ADDENDUM # 3

**PROJECT: New Surface Parking Lot
St. Ferdinand Street, Baton Rouge, LA 70802
CITY PARISH PROJECT NO. 20-ASC-CP-1515**

Contractors' General Questions

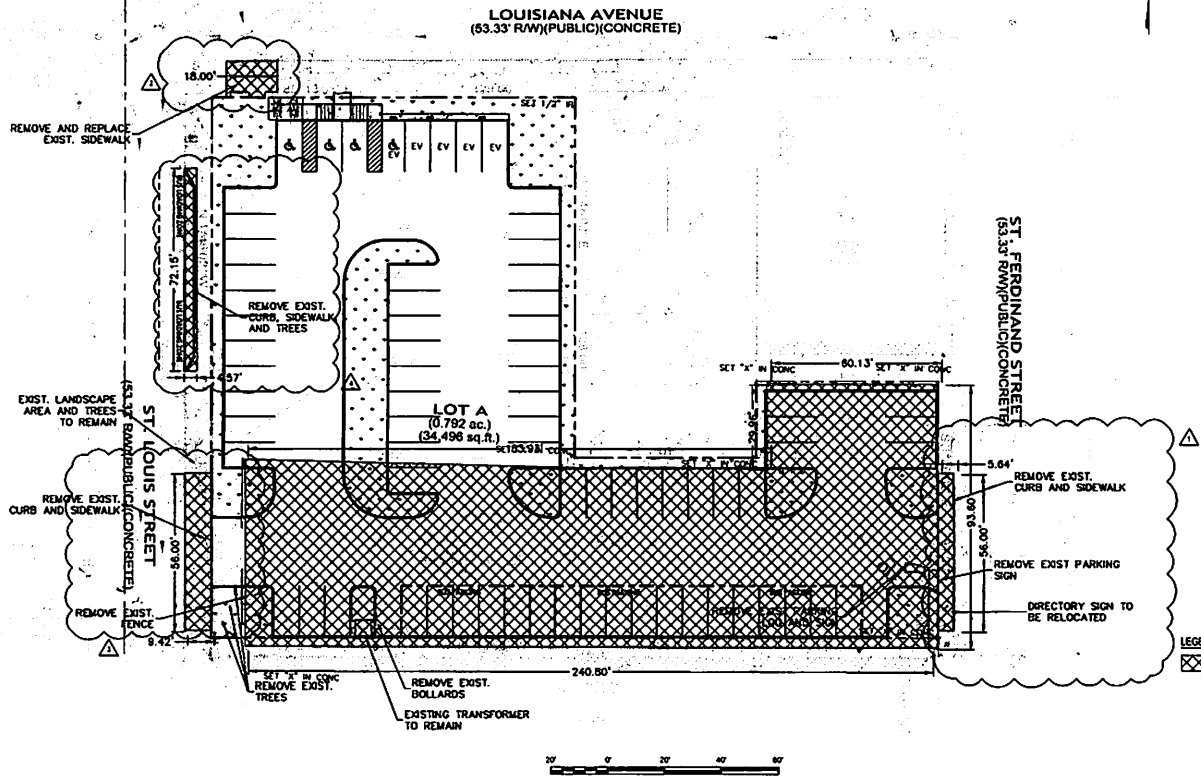
15. Detail 6 has a call out in reference to Note 7, but there isn't a note 7. Please advise.

- a. Detail 6 previously instructed the reader to refer to note 7, which did not exist. This text has been changed to refer to note 5.

DATE: 5/17/2024, 11:38 AM | AUTHOR: jay@jts.com | (PLOTTER: DWG TO PDF.pc3) |
 PATH: C:\Users\jts\OneDrive\Documents\2023\ST Ferdinand Parking Lot\Drawings\1-C1 Demolition Plan.dwg | (LAYOUT: C1)

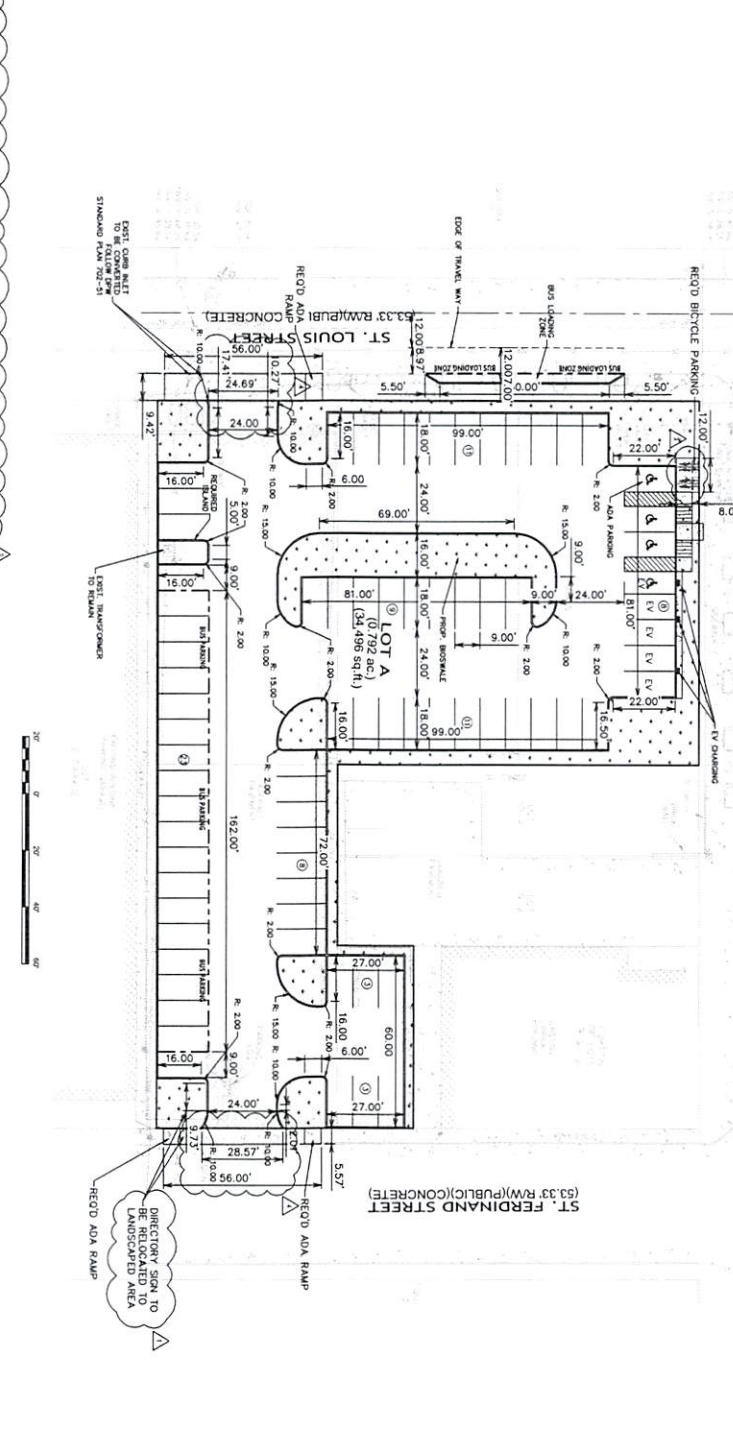
- 1. There is no demolition indicated at the connection to St. Ferdinand Street. Please advise.**
 - a. See revised sheet C1 – Demolition Plan
- 2. There is no demolition indicated at the storm drain tie in at Louisiana Avenue. Please advise.**

- a. See revised sheets C1 – Demolition Plan for demolition requirements.
- 3. There is an existing 6" steel pipe that connects to the existing inlet at Louisiana Avenue and St. Louis Street. Is this to remain?**

- a. The 6" steel pipe shown is to remain.
- 4. Is the existing fence to be removed?**
 - a. See revised sheet C1 – Demolition Plan
- 5. There is an existing wayfinding sign in the sidewalk along St. Ferdinand Street that is in conflict with the apron. Is this to be removed?**

- a. The apron has been revised to avoid conflict with the sign. See revised sheet C1 – Demolition Plan
- 6. Will ADA matting be required where the sidewalk intersects the aprons?**

C3
SHEET NUMBER

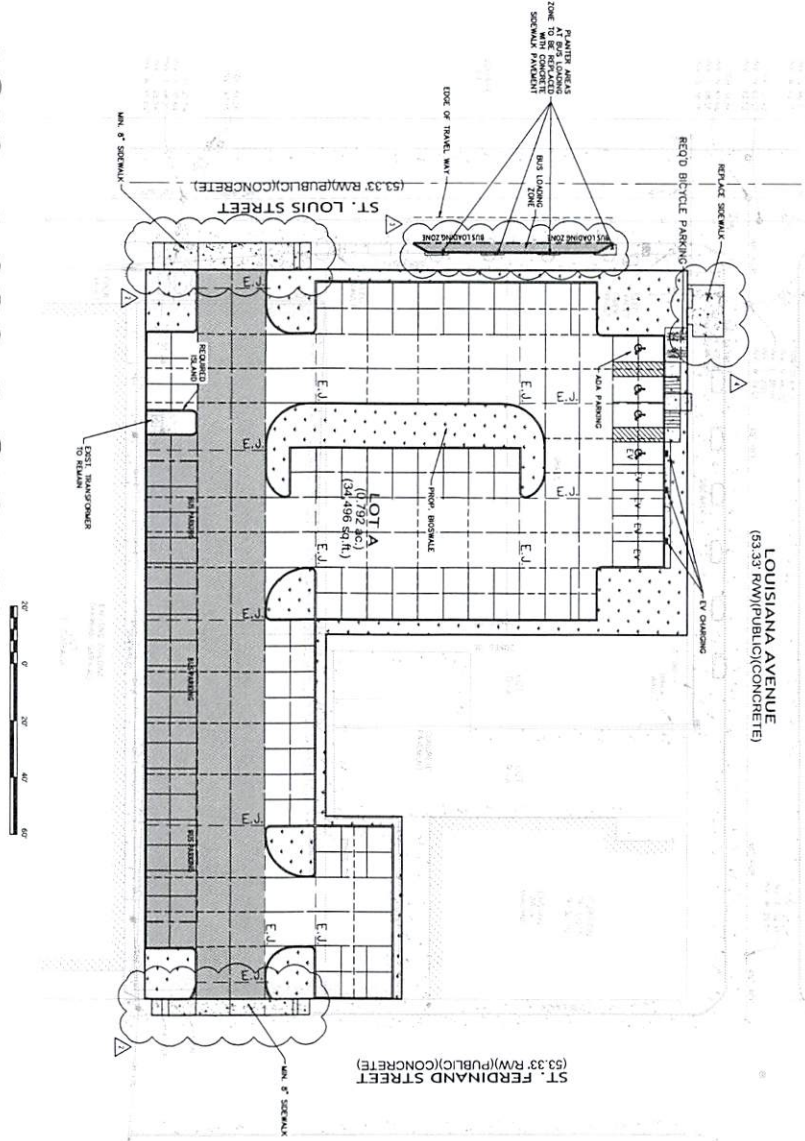
- 8. Are any wheel stops required for this project?**
 - a. Wheel stops are required at all parking stalls. Wheel stop detail shown on sheet C7.
- 9. Note 7 mentions permeable paving, is any of the paving for this project to be permeable?**

- a. Note 7 removed from sheet C3. No pavement to be permeable paving.

SHEET NUMBER
C4

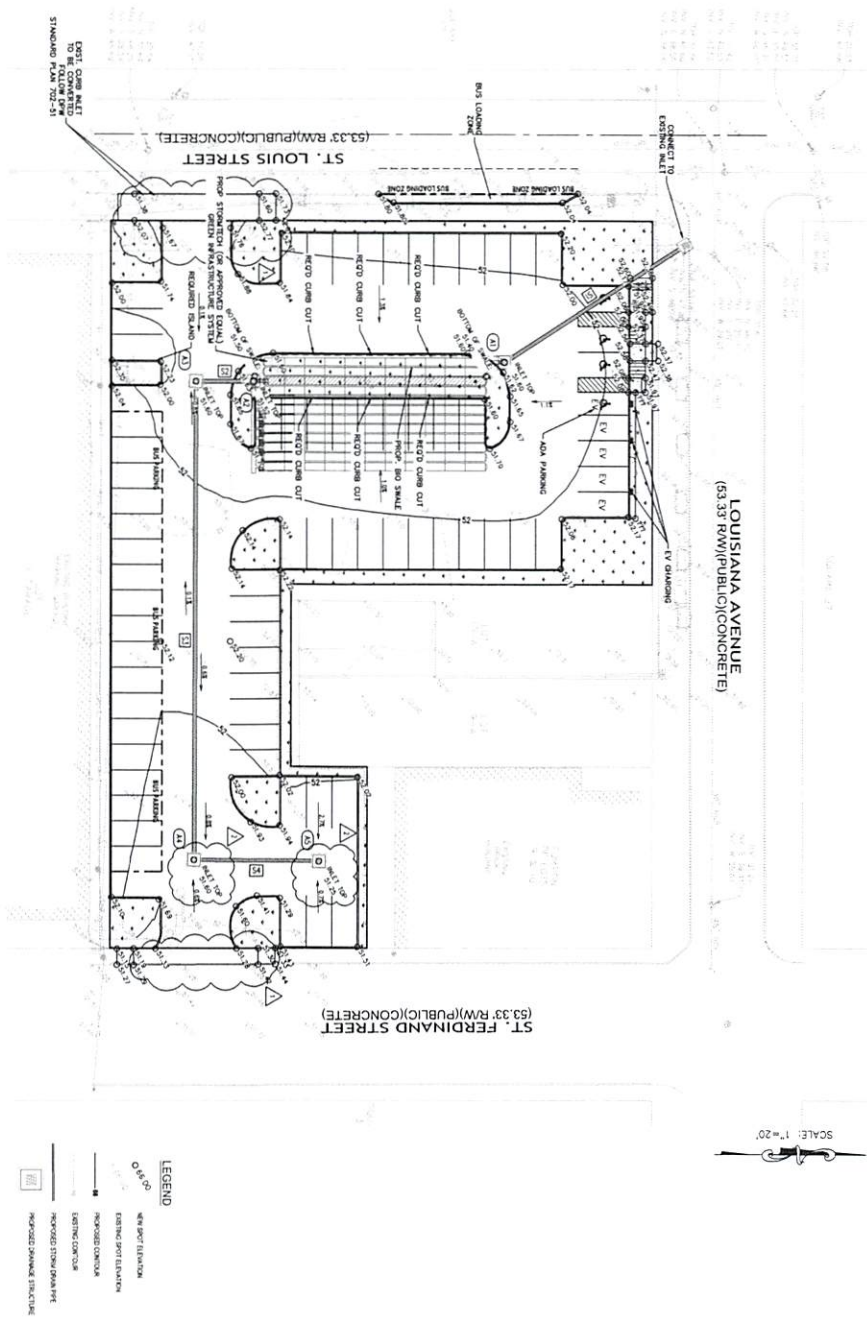
10. Per note 9, all pipe is to be RCP. Much of the pipe is 12", which isn't a common size. Would it be acceptable to use 15" RCP in lieu of 12" for these pipe runs?

- a. Note states "Storm drainage pipe may be ribbed PVC pipe conforming to ASTM F-794 series or ASTM C-76 class III reinforced concrete pipe". Pipe sizes have also been revised. See sheet C4 and C5.

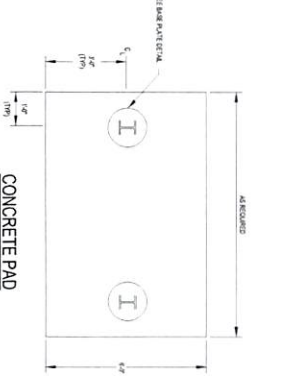
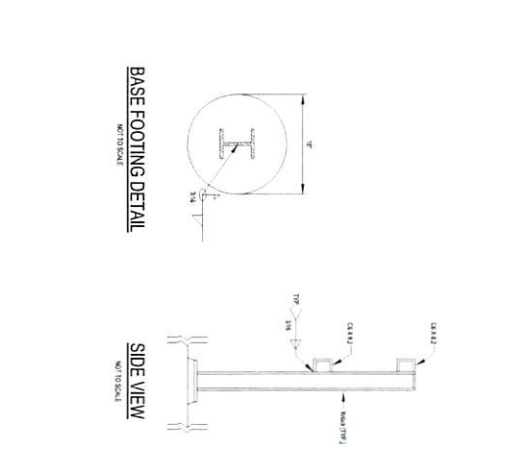
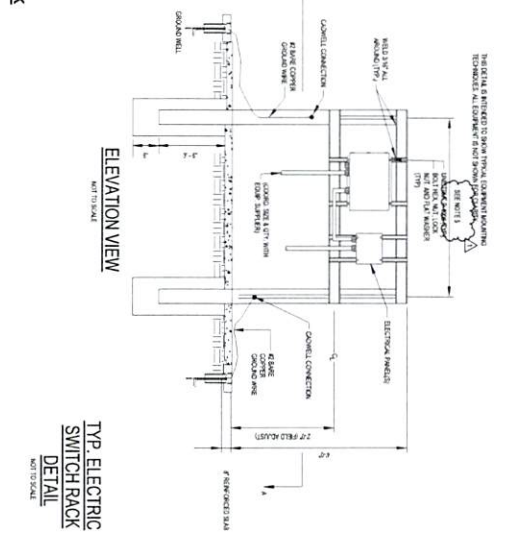
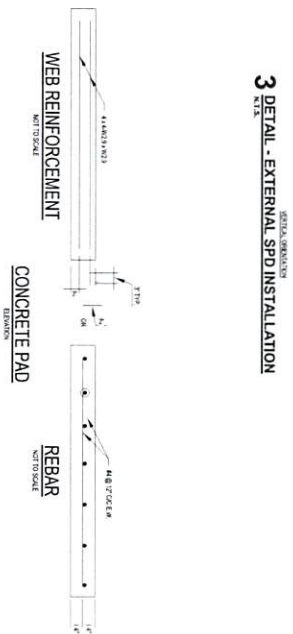
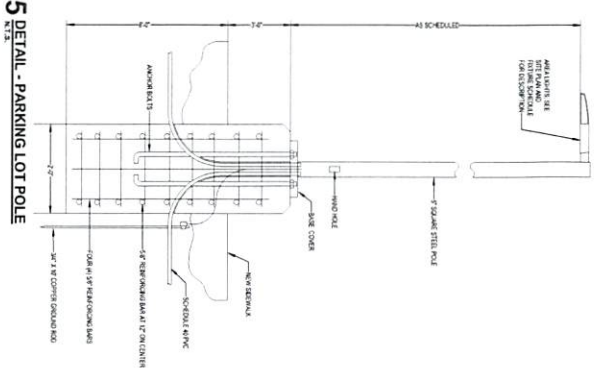
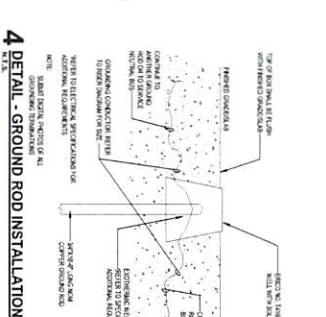
13. Are the handicap signs shown in detail 14 required for this project?

14. In the inlet filter in detail 2 meant for use during or post construction?

- a. All handicap signs shown in sheet C7 – Standard Details, are required for this project.

- a. The inlet filter is to be installed during installation of the storm drain inlets. Inlet protection detailed is required throughout construction as well.
